MAINTENANCE INSTRUCTION

MODERNIZATION RECOMMENDATION VR13 MODULE IMPROVEMENTS

Fig.1 - Circuit Diagram VR13

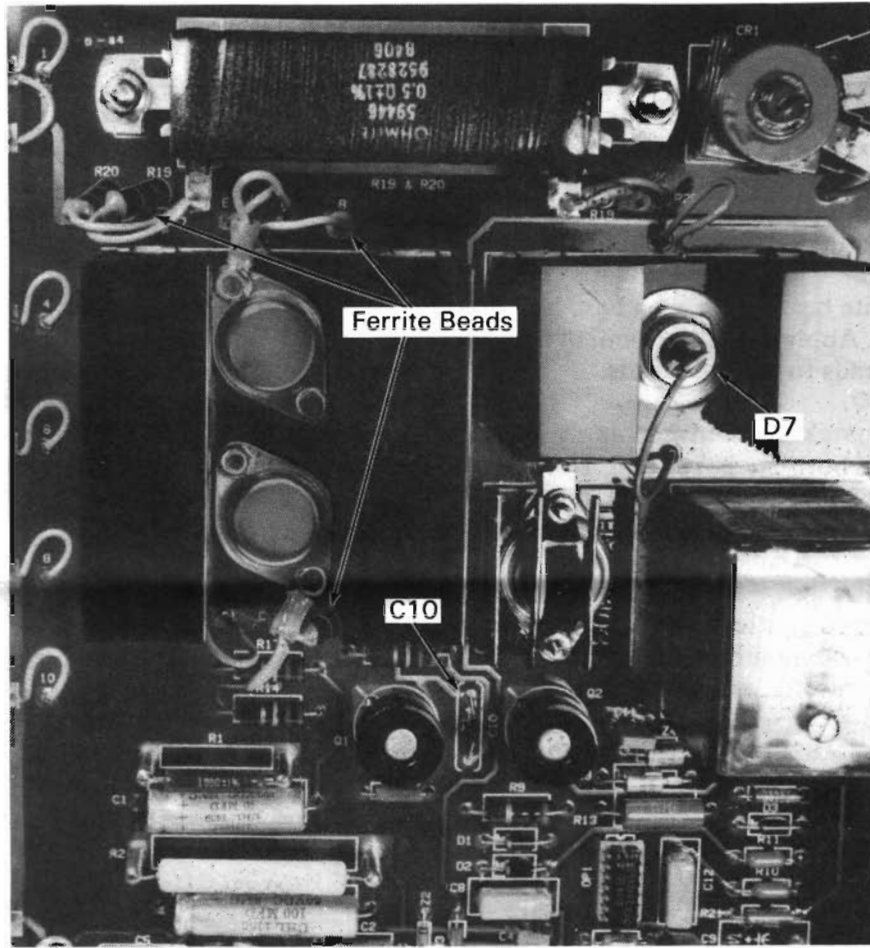
REPLACEMENT OF Q4 & Q5 AND ADDITION OF FERRITE BEADS, Figs. 1, 2, & 3

Transistors Q4 and Q5, part number 9321802, are to be replaced by transistor part number 9542836. In order to accomplish this, the following steps should be taken.

1. Remove the four 1/4" bolts from the back of the circuit board that retains the heat sink for Q4 and Q5.
2. Rotate the heat sink 90 degrees as shown in Fig. 3.
3. De-solder the base and emitter leads at the transistors.

4. Unbolt and remove the collector leads at the transistors.
5. Remove the heat sink and transistor assembly. Replace the existing Q4 and Q5 with new 9542836 transistors. Apply a small amount of heat sink compound under the cases of Q4 and Q5 before mounting to the heat sink.

Fig.2 - Application Of Ferrite Beads

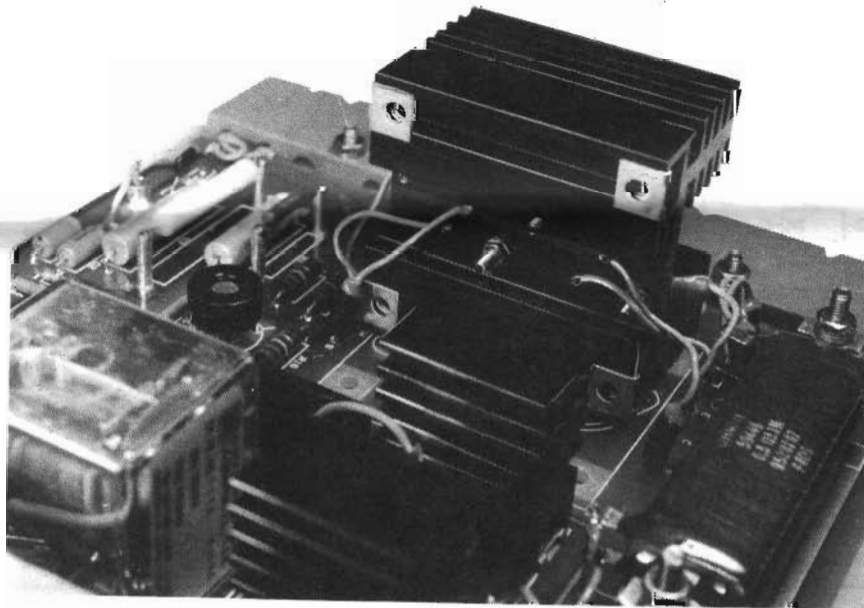
6. Slide three ferrite beads over each base lead as shown in Fig. 2. Apply a small amount of epoxy to secure the beads to the base leads.
7. While the heat sink is removed, apply three ferrite beads to both leads running from the R19 & R20 resistors to the circuit board as shown in Fig. 2. Apply a small amount of epoxy to secure the ferrite beads to the leads.

Capacitor C10 should be added in the location as shown in Fig. 2. Some VR13's may have a capacitor presently in the C10 location. If so, it should be removed and replaced with the new capacitor. On those modules without a capacitor, C10 should be added.

Fig.4 - Pictorial Indicating Modified Items

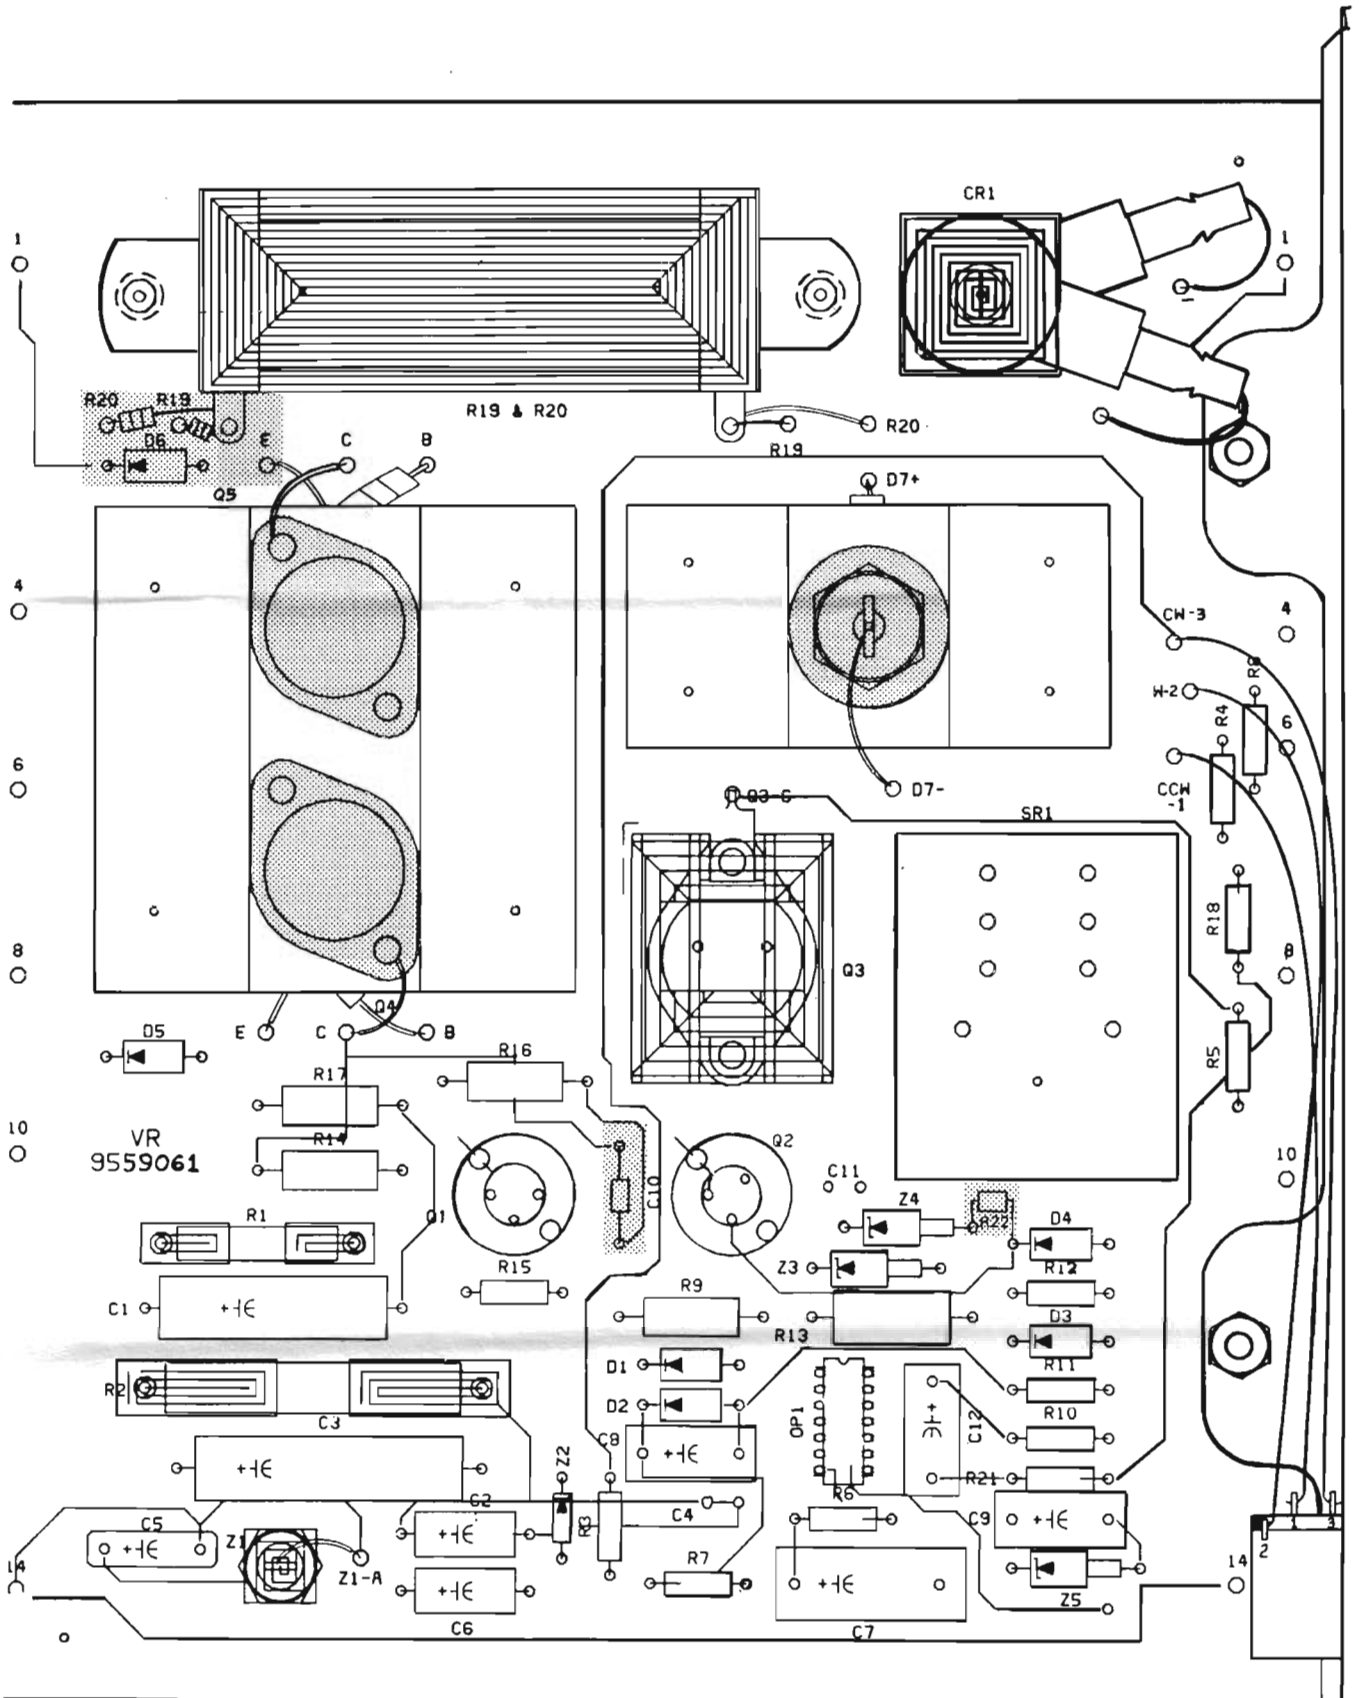
Under certain environmental conditions, transistors Q4 and Q5 have been found to lose regulation due to leakage current at the base of the transistors. The addition of R22 reduces the sensitivity of the VR13 Module to humidity.

To modify the module attach the resistor to the top side of the board from the cathode of D4 (left side) to the anode (right side) of Z4, Fig. 4.

Once all of the modifications have been made, the module should be sprayed with conformal coating, concentrating on the newly soldered connections.
